SUBJECT: SHEARON HARRIS NUCLEAR POWER PLANT, UNIT 1 - STAFF ASSESSMENT OF INFORMATION PROVIDED PURSUANT TO TITLE 10 OF THE *CODE OF FEDERAL REGULATIONS* PART 50, SECTION 50.54(f), SEISMIC HAZARD REEVALUATIONS FOR RECOMMENDATION 2.1 OF THE NEAR-TERM TASK FORCE REVIEW OF INSIGHTS FROM THE FUKUSHIMA DAI-ICHI ACCIDENT (TAC NO. MF3952)

STAFF ASSESSMENT BY THE OFFICE OF NUCLEAR REACTOR REGULATION

RELATED TO SEISMIC HAZARD AND SCREENING REPORT

SHEARON HARRIS NUCLEAR POWER PLANT, UNIT 1

Figure 3.3- 1 Plot Comparing the Staff's and the License's Median Amplification Functions and Uncertainties for the HNP site

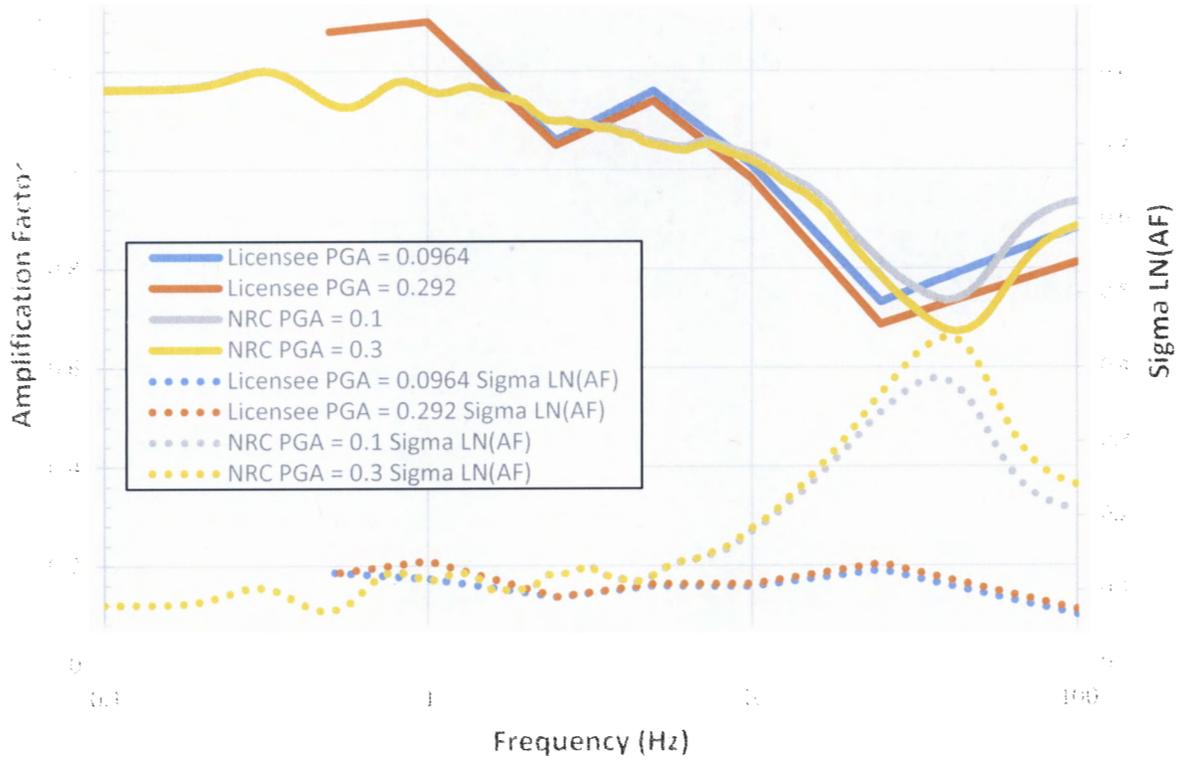
Figure 3.3-2 of this assessment shows a comparison of the staff's and the licensee's median site amplification functions and uncertainties (± 1 standard deviation) for two of the eleven input loading levels. Peaks in the amplification functions occur at approximately 1 and 5 Hz in the licensee's analysis, while the staff's analysis resulted in relatively constant amplification functions below 2 Hz, and a modest decrease between 2 and approximately 10 Hz. There are large differences in uncertainties at high frequencies due to the NRC staff using greater uncertainties in both kappa and damping parameters. Differences in site amplification curves developed by the NRC staff and the licensee are due to differences in site velocities, kappa values, and damping parameters.

Figure 3.3-2 Plot Comparing the Staff's and the Licensee's Mean Control Point Hazard Curves at a Variety of Frequencies for the HNP site

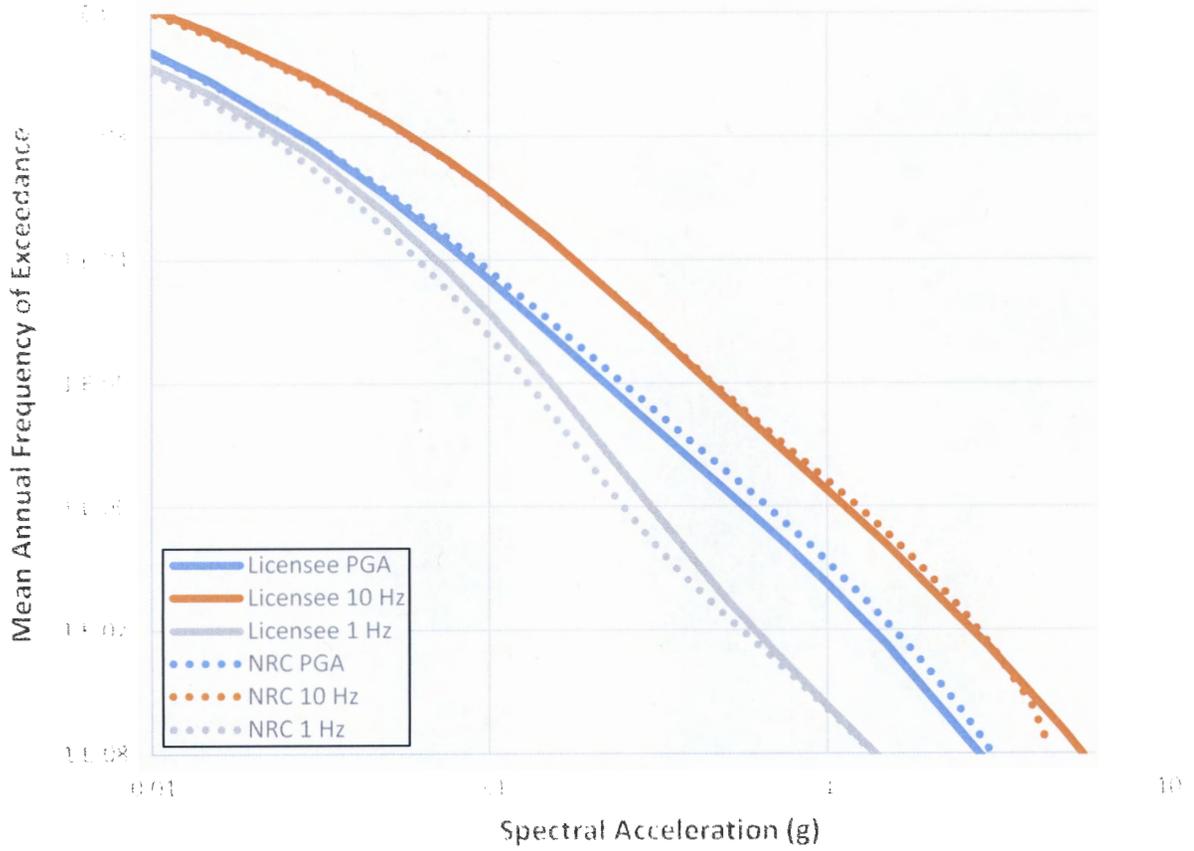
The licensee's approach to modeling the subsurface soil and rock properties and their uncertainties results in amplification factors that are broadly similar to those produced by the NRC staff, with the exceptions noted above. As shown in Figure 3.3-3 of this assessment, these differences in site response have a minor impact on control point seismic hazard curves and the resulting GMRS, discussed below. Appendix B of the SPID provides guidance for performing site response analyses, including capturing the uncertainty for sites with less subsurface data; however, the guidance is neither entirely prescriptive nor comprehensive. As

Figure 3.4-1 Comparison of the Staff's GMRs with Licensee's GMRs and the SSE for the HNP site

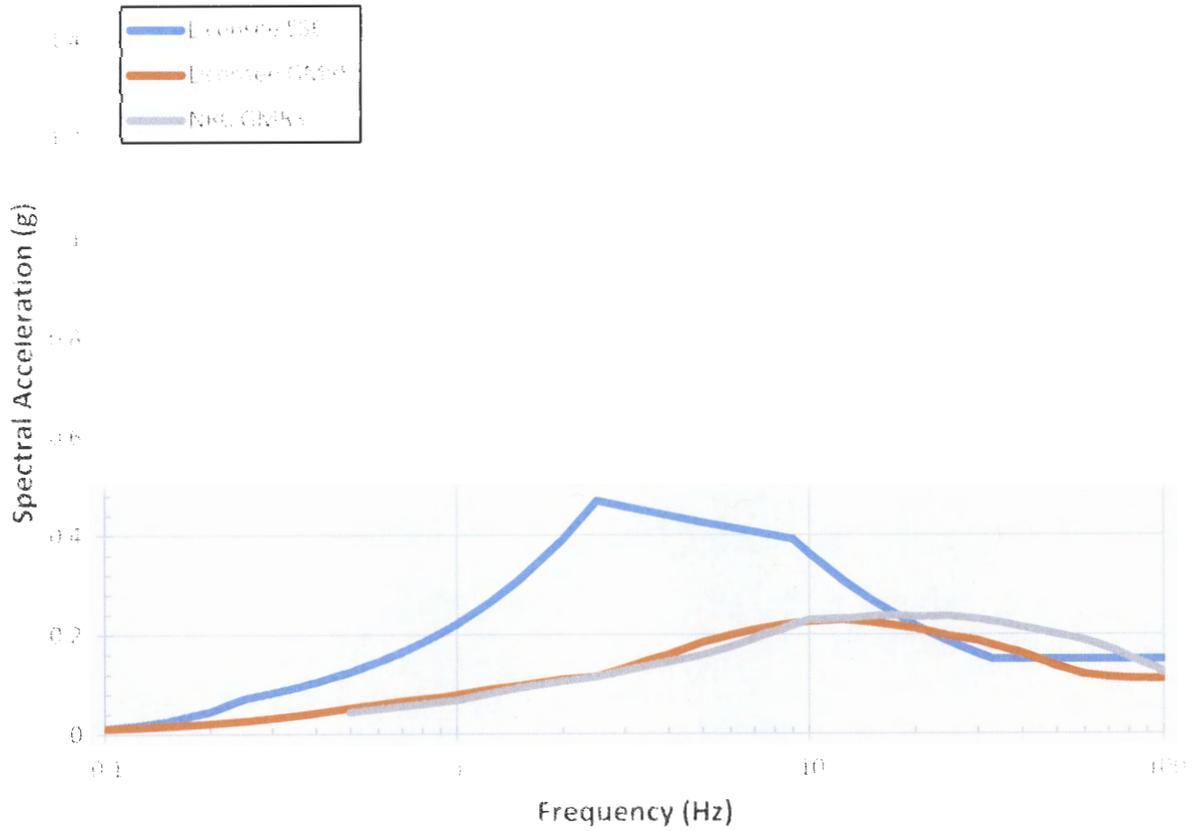
The NRC staff independently calculated the 10^{-4} and 10^{-5} UHRS using the results of its confirmatory PSHA and site response analyses, as described in Sections 3.2 and 3.3 of this staff assessment, respectively. Figure 3.4-1 of this assessment shows a comparison of the GMRS determined by the licensee to that determined by the NRC staff.

As shown in Figure 3.4-1, the licensee's GMRS is similar to the staff's confirmatory GMRS. However, the NRC's GMRS is slightly higher than the licensee's GMRS at frequencies above 15 Hz. As described above in Section 3.3, the NRC staff notes that these differences are the result of differences in the site response analyses performed by the licensee and the NRC staff.

The NRC staff confirms that the licensee used the present-day guidance and methodology outlined in RG 1.208 and the SPID to calculate the horizontal GMRS, as requested in the 50.54(f) letter. The NRC staff performed both a PSHA and site response confirmatory analysis and achieved results consistent with the licensee's horizontal GMRS. As such, the NRC staff concludes that the GMRS determined by the licensee adequately characterized the reevaluated hazard for the HNP site. Therefore, this GMRS is suitable for use in subsequent evaluations and confirmations, as needed, for the response to the 50.54(f) letter.
